PLANNING STAFF REPORT
Conditional Zoning Map Amendment

Hearing Date: August 2, 2016 Planning Board
September 19, 2016 BOCC
Applicant: DRC Hampstead, LLC
Property Owner: Jesse F. Lea SR et al
Case Number: CZMA 305-2016

Case 305 – 2016 Major Site Plan – Conditional Zoning Map Amendment Sparrows Bend

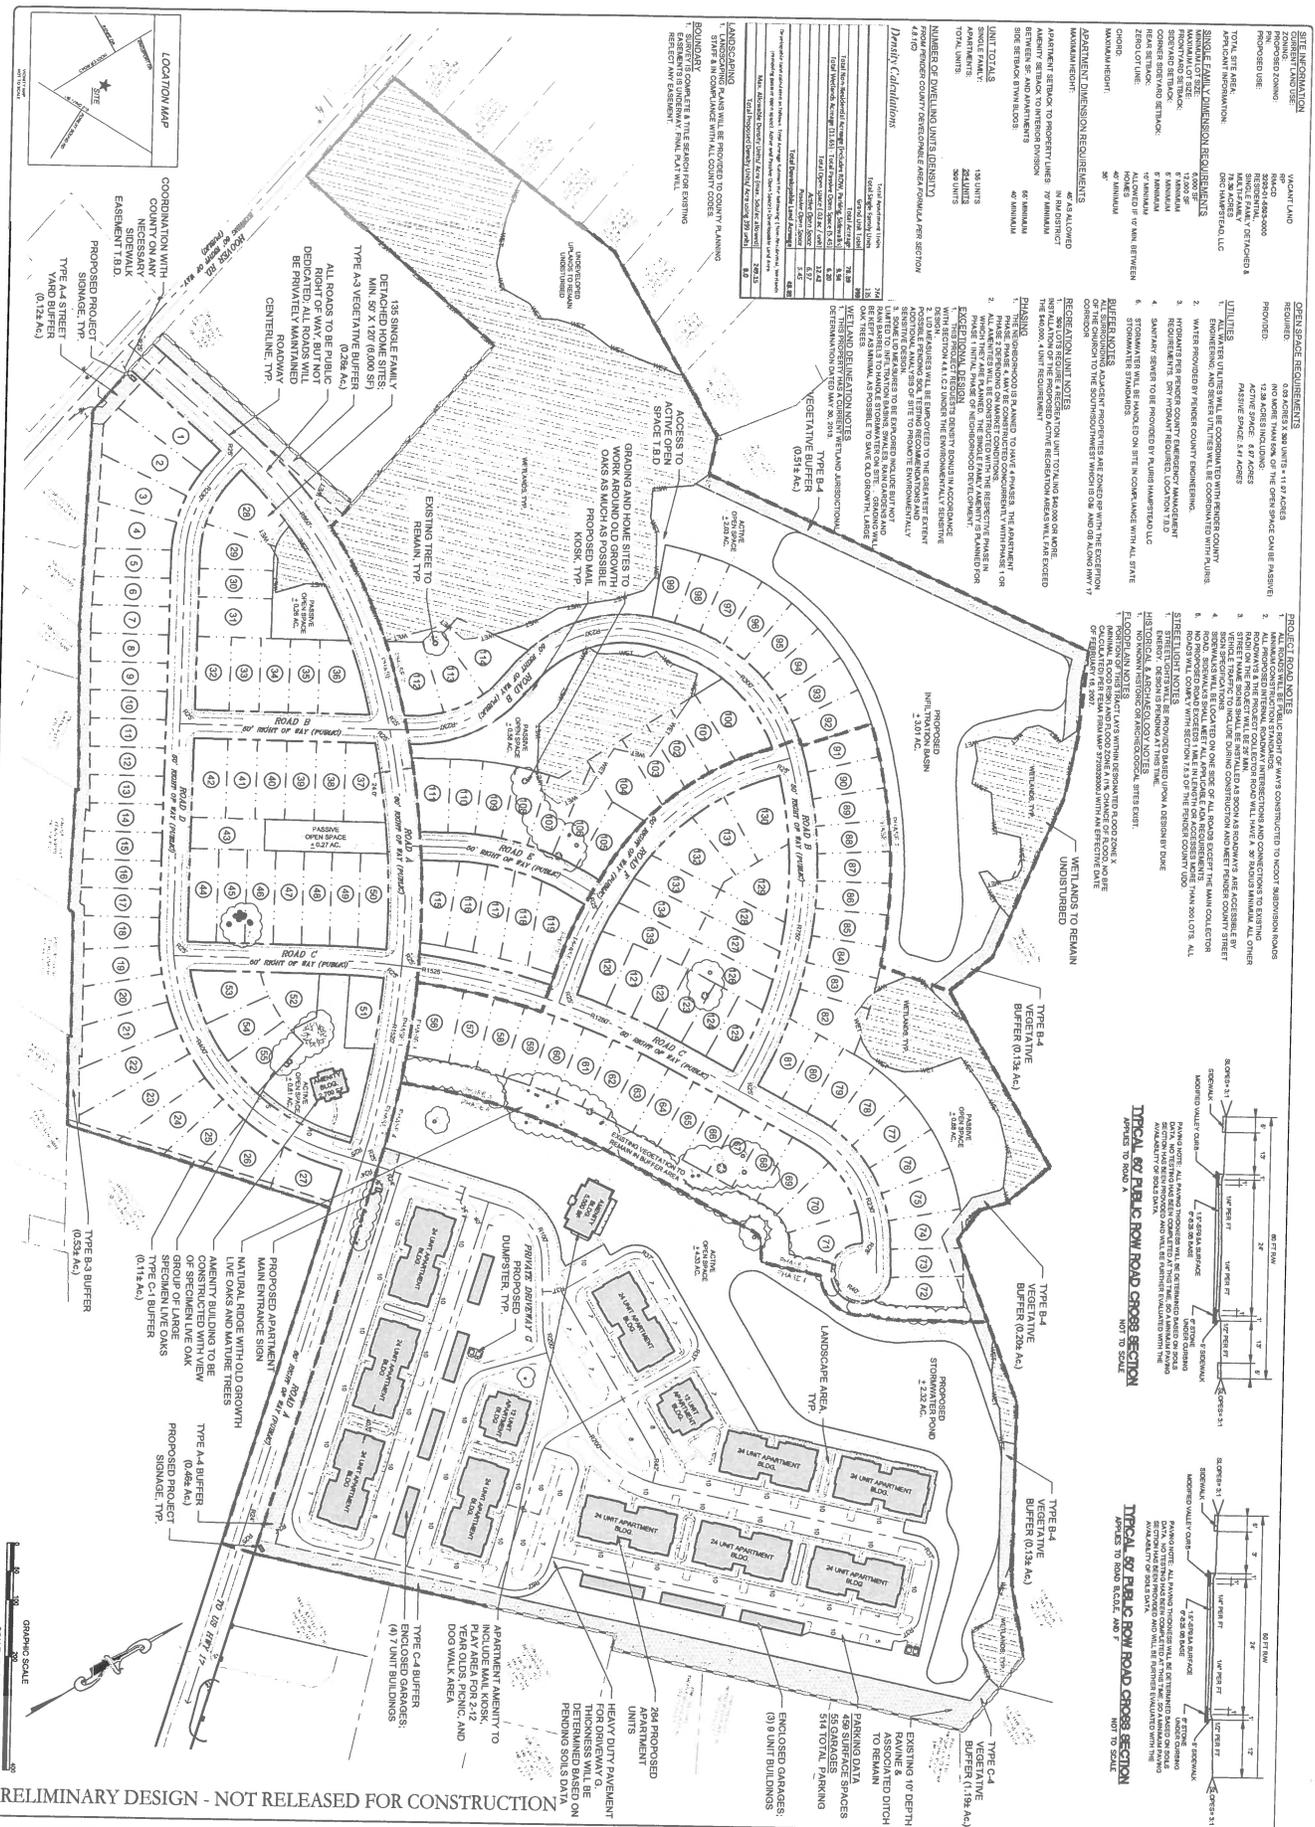
3. The proposed site plan does not show approved street names for this development.
4. Increase the pavement cross section of the proposed streets. The proposed Road A appears to be operating as a Collector Street for the Site and the Pender County Collector Street Plan. Greater thickness of asphalt and base stone is required for collector streets.

5. Provide a Cul-De-Sac cross section for the end of proposed Road C Cul-de Sac.
6. Add typical roadway geometry dimensions to the plans, such as Horizontal Centerline Radius, Street Corner Radius, etc.

7. Provide sidewalk for the missing section of Road B, from the intersection of Road D to Road A.
8. Provide Sidewalk along Road A from Road D to the entrance to the subdivision.

9. Provide a public street into the apartments for Phase 4. The current design has a single driveway entrance and an internal parking lot network. There is over 1330' from the Road A intersection to the last two apartment buildings in the phase.

- Property Line
- Wetlands
- Proposed 100' Access Road
- Approximate Wetland Impact - ~2 acres
- Potential Wetlands

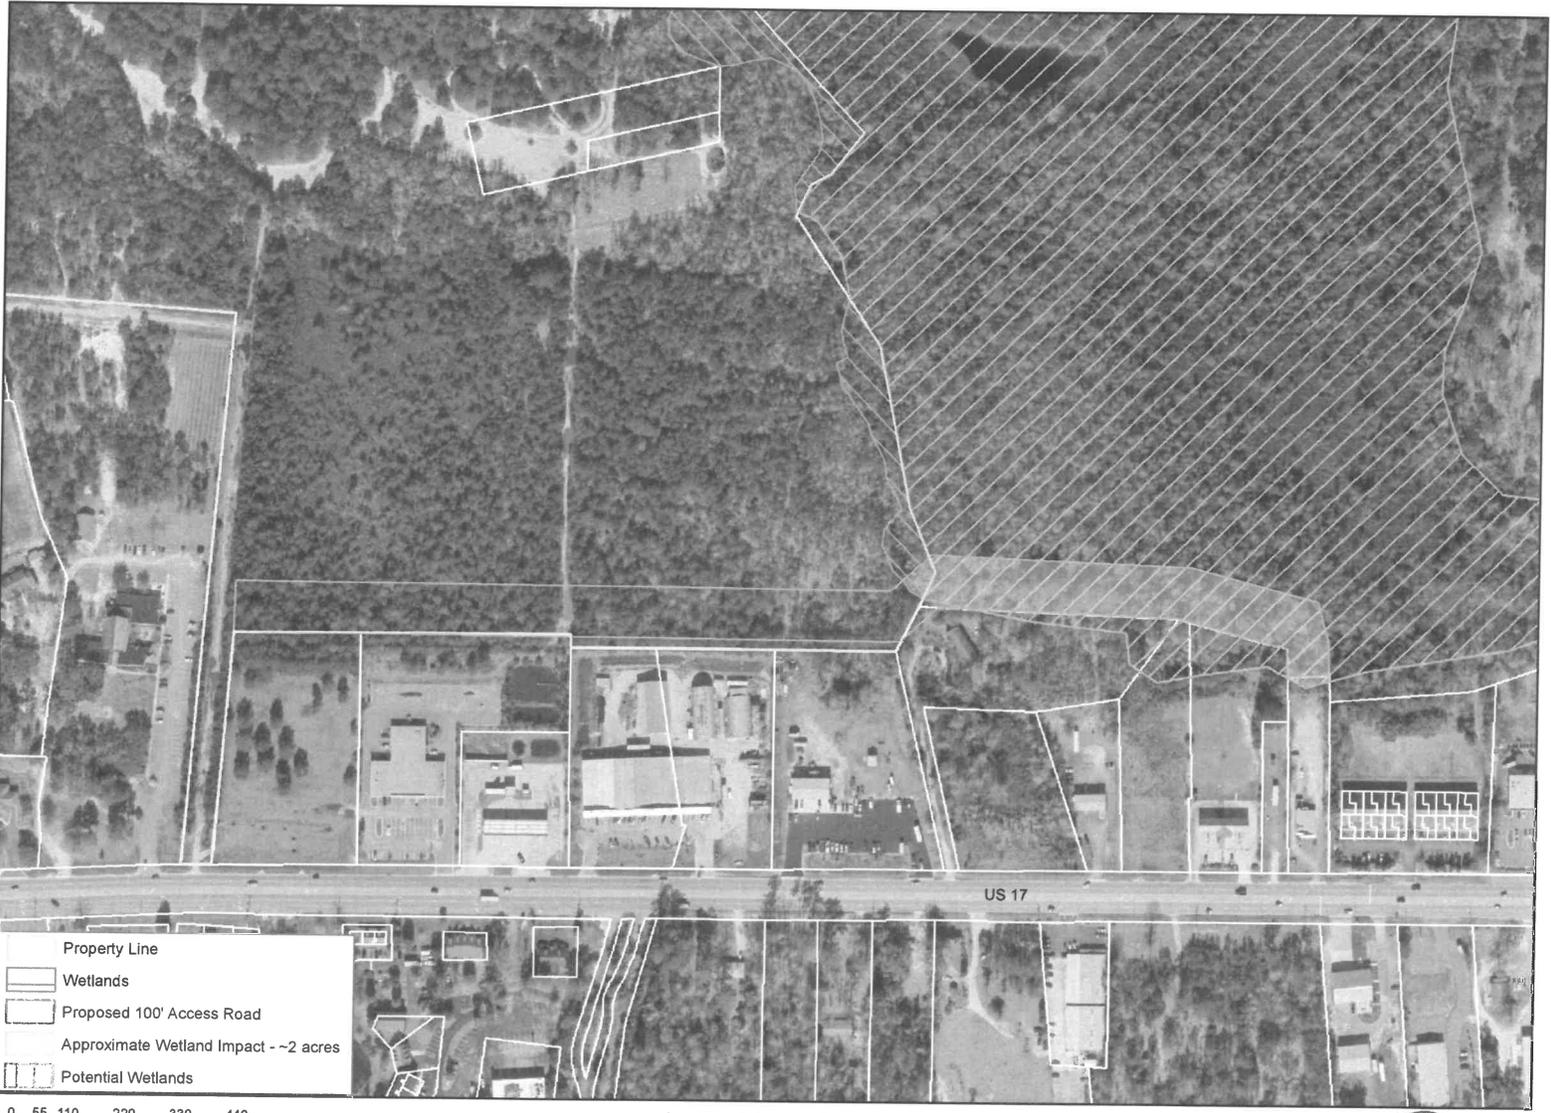
Based on the Pender County Collector Street Plan (CSP) the access road will require a USACE wetland permit or the construction of a pile supported bridge. It is my understanding that the size and construction of a bridge in this location is not economically practical and a traditional earthen filled wetland crossing would be more suitable. The wetland impact area for the roadway would be approximately 2.0 acres which is a significant impact for a road crossing and would require adequate justification. (see Exhibit)

The USACE requirements for this type of road crossing require a purpose and need for the impact that is clearly definable and defensible. After reviewing the Pender Street Collector Plan the proposed access road would provide access to residents and businesses which are already accessed from Highway 17, which questions the need for additional access. Future development within the wetlands to the west of the proposed road (adjacent to the impact area) is also unlikely as both construction restrains and significant wetland impacts would be required. This also limits the need for the access road and therefore the purpose of the proposed wetland impact.
